UNITED STATES PATENT AND TRADEMARK OFFICE

APPLICATION NO.	FILING DATE	FIRST NAMED INVENTOR	ATTORNEY DOCKET NO.	CONFIRMATION NO.
10/757,235	01/14/2004	Jeffrey K. Daniel	123018.0002.000	3258

Office Action Summary	Application No. 10/757,235	Applicant(s) DANIEL, JEFFREY K.	
	Examiner Roger L. Pang	Art Unit 3681

DETAILED ACTION

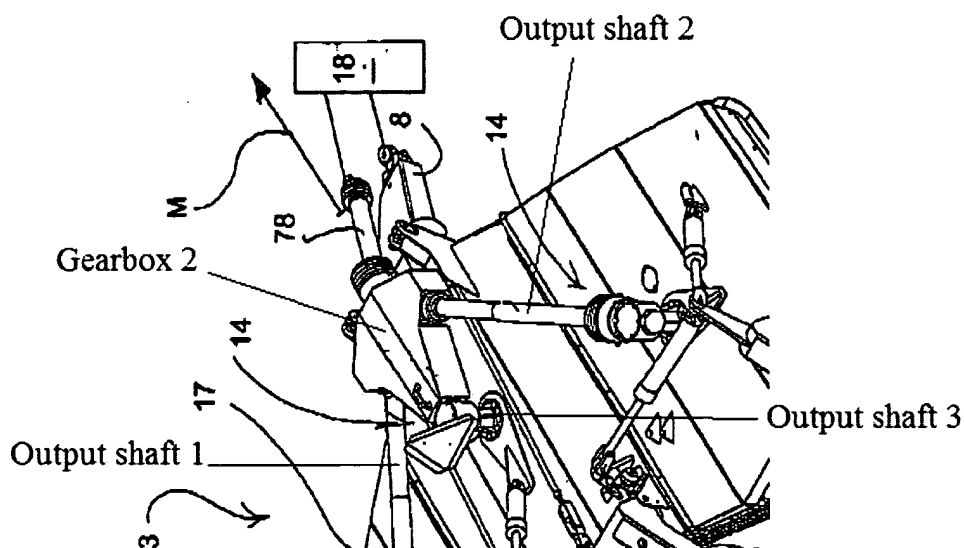
With regard to the Stevenson reference, shaft 78 (Fig. 2) is the output shaft of gearbox 75 (Fig. 6). See page 4, paragraph 46. The output shafts of the second gearbox are shown in the diagram below:
